Re: IDPR Project No. 350341

Bear Lake State Park – Bear Lake North Beach Redesign Idaho Department of Parks & Recreation St. Charles, Idaho

NOTICE OF CHANGES:

SHEET NUMBER: C-101

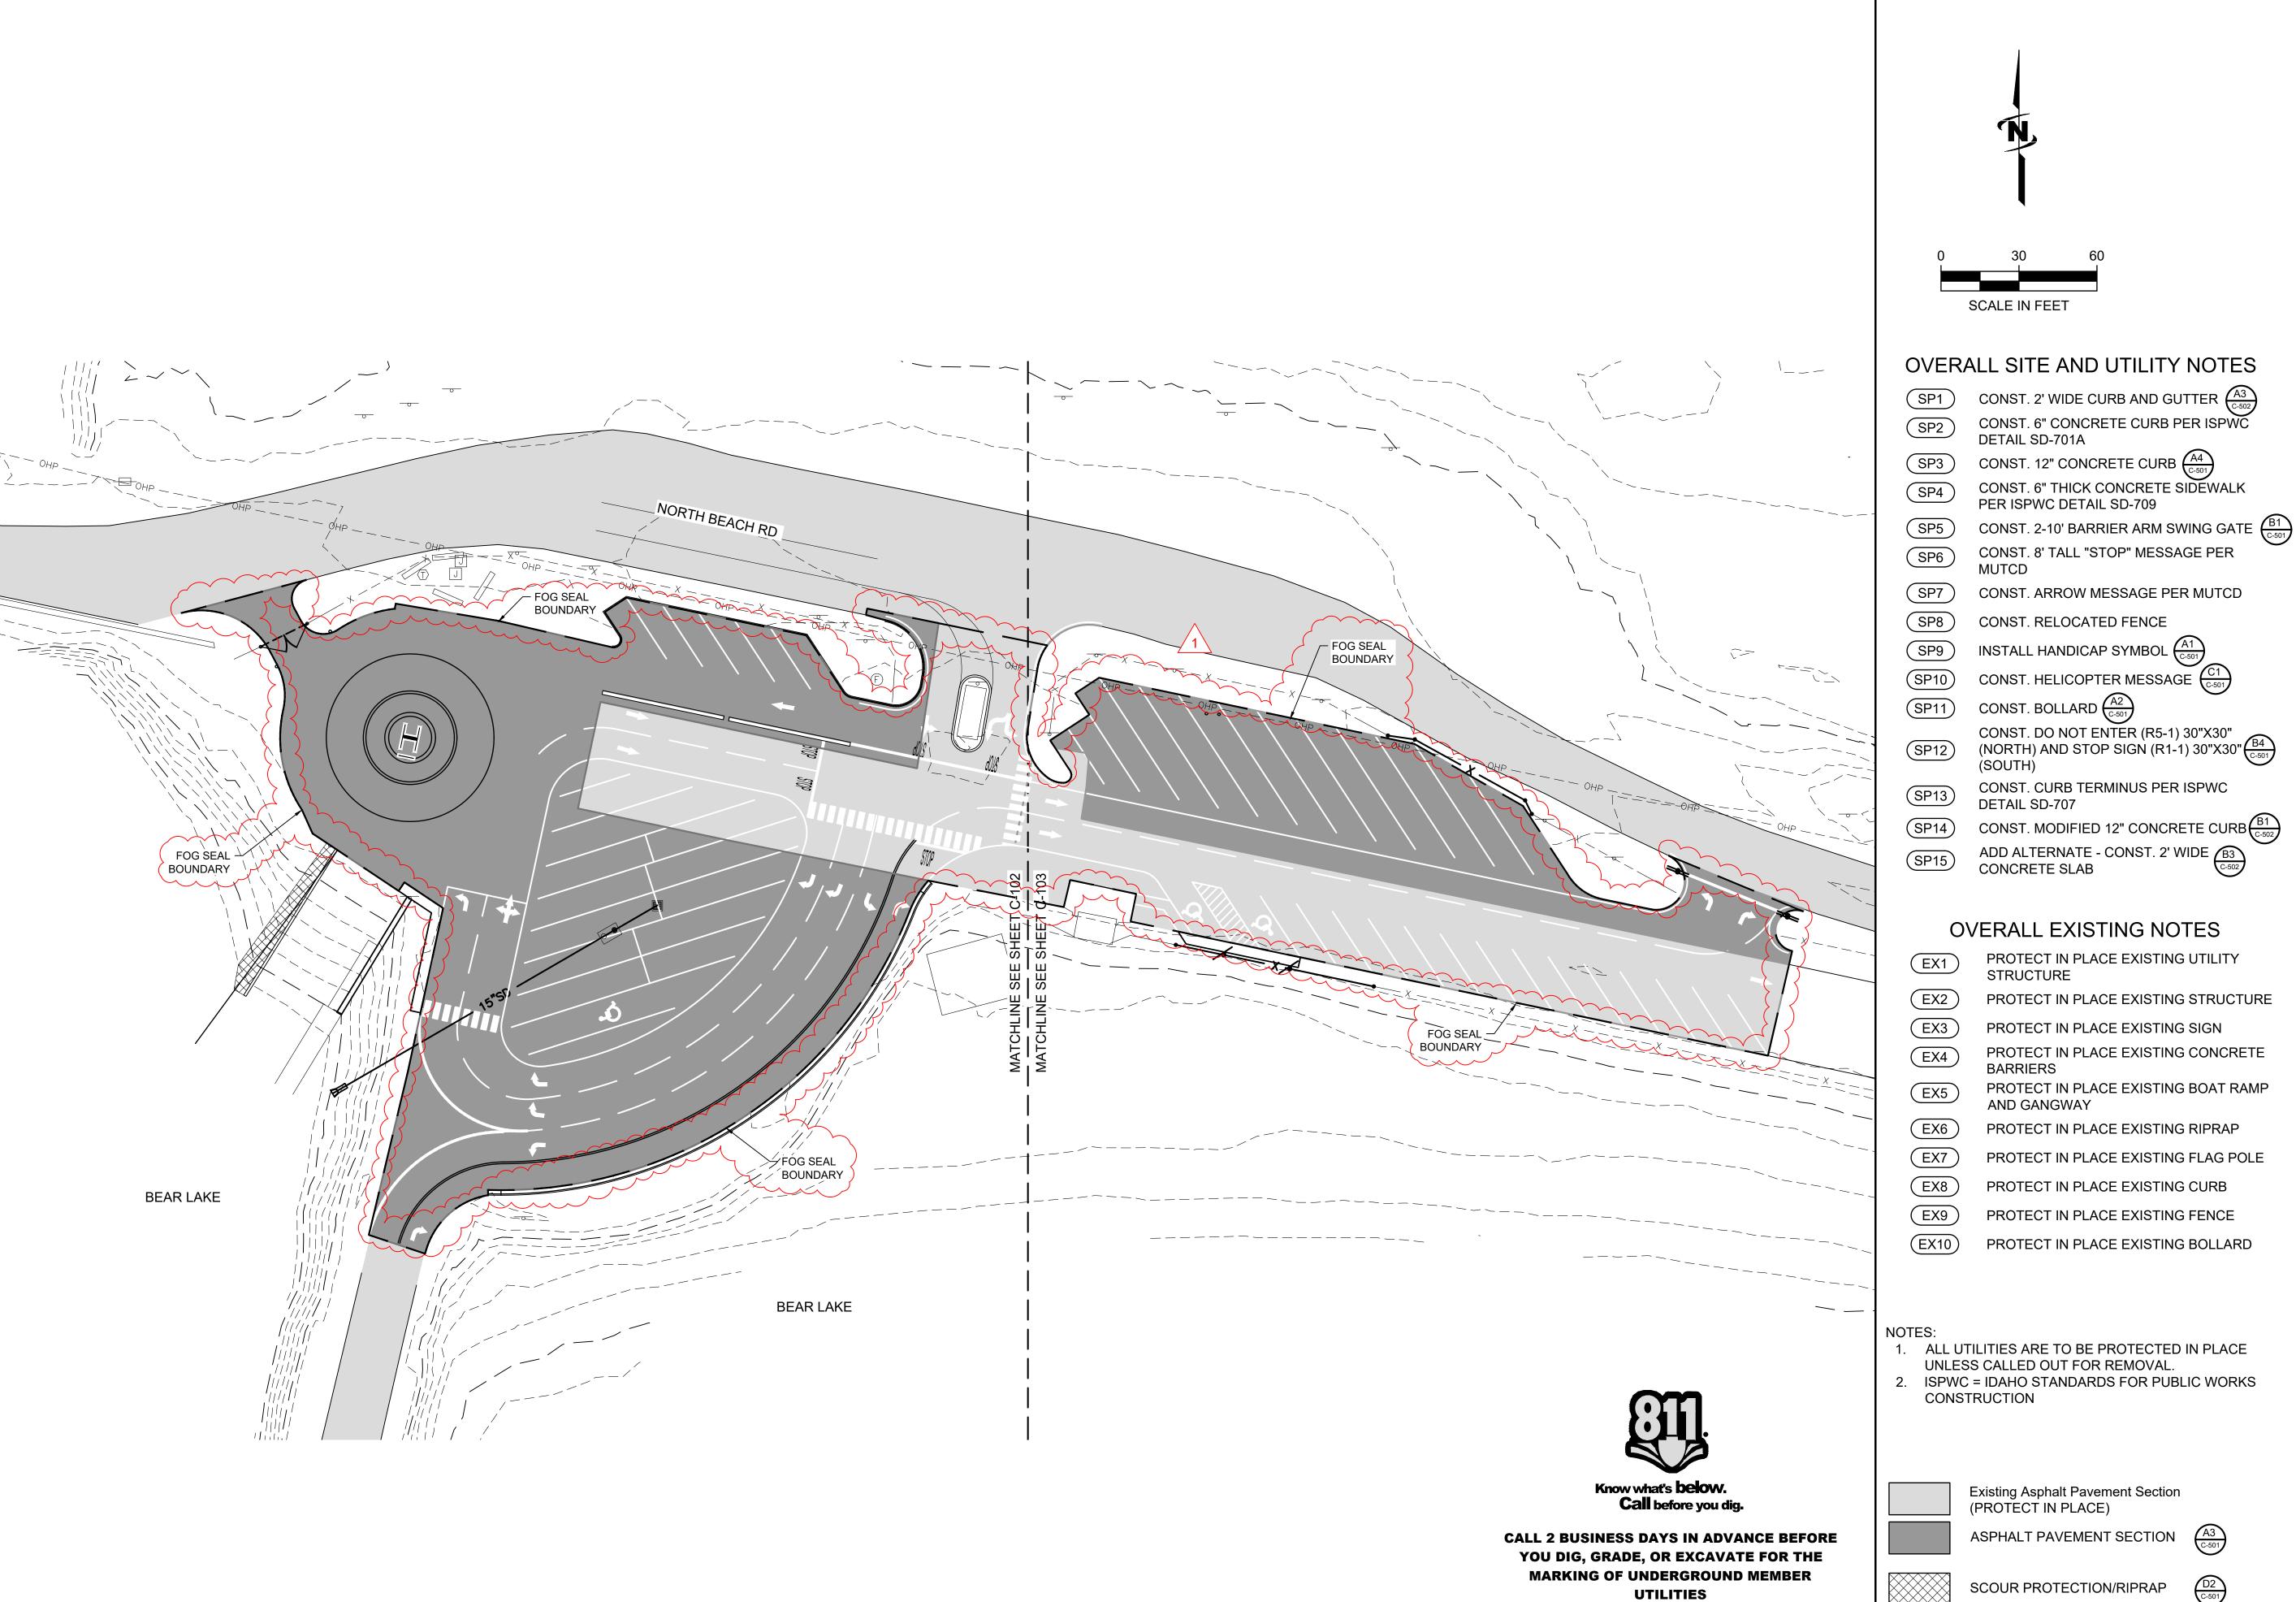
- 7. Can you clarify the area of addendum 1 for the additional asphalt paving will be? A: The area is specified in the attached C-101 drawing.
- 8. There is a detail on the plan D2 "Scour Protection/Rip Rap, where on the project is this required to be installed?

- 1. Drawings
 - a. C-101 Shows boundary of fog seal and limits of asphalt for Alternate 1.
 - b. C-103 Shows the change in ADA access to the restroom from concrete to asphalt striping.
